INTRODUCTION:

The PJM Designated Entity Design Standards ~~Task Force (DEDSTF)~~ were formalized by PJM to conform in part to FERC Order 1000. They are intended to apply to facilities proposed/requested in accordance with the process defined in the Open Access Transmission Tariff (“OATT”). They are intended to provide common PJM transmission provider criteria concerning design philosophy, design requirements and operating practices for Transmission Facility Owners. These requirements are intended to be the minimum standards to which any entity ~~must shall~~ design and ~~built-build~~ to in the PJM territory. Transmission Owners (“TO’s”) traditionally have additional technical interconnection requirements that may be greater than the requirements outlined below. The transmission Technical Interconnection Requirements must be considered throughout the process.

Figure 1 – One-Line diagram showing elements and non-elements

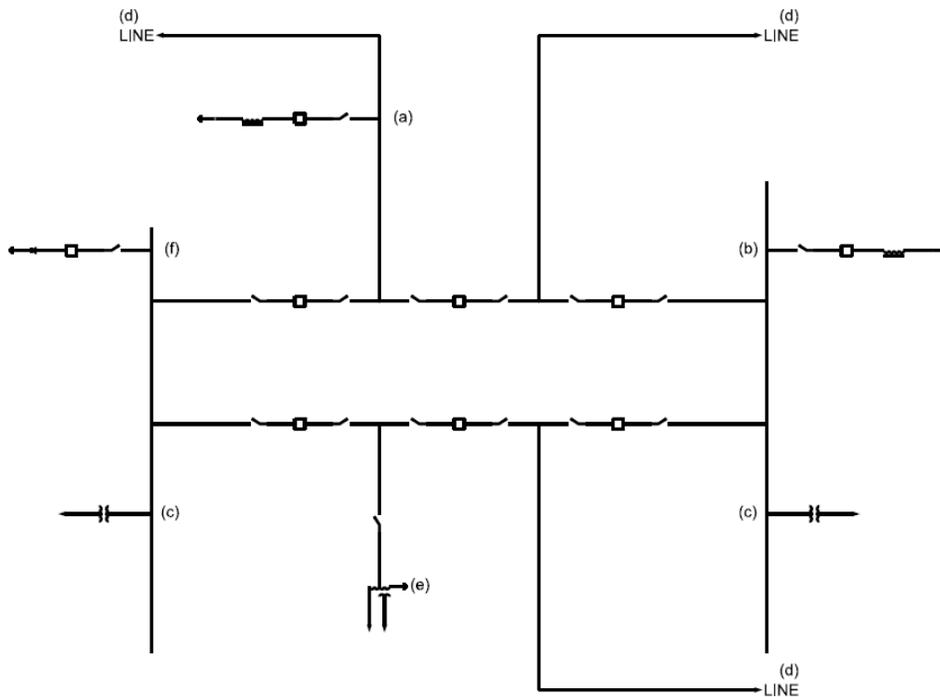
Comment [MA19]: I think this needs to be carefully considered. Reactive devices need their own switching breaker so you don't have to open the ring or BAAH bus every time you want to switch the device. This means that it will require 2 CB's to put a cap on a ring or 2.5 to put one on a BAAH. I think it makes sense to allow a reactive device to be connected to the main bus of a BAAH with one CB instead of putting in on one of the rungs. You also need to look at what happens if it gets isolated onto adjacent line.

Comment [MA20]: Auto-restore not allowed?
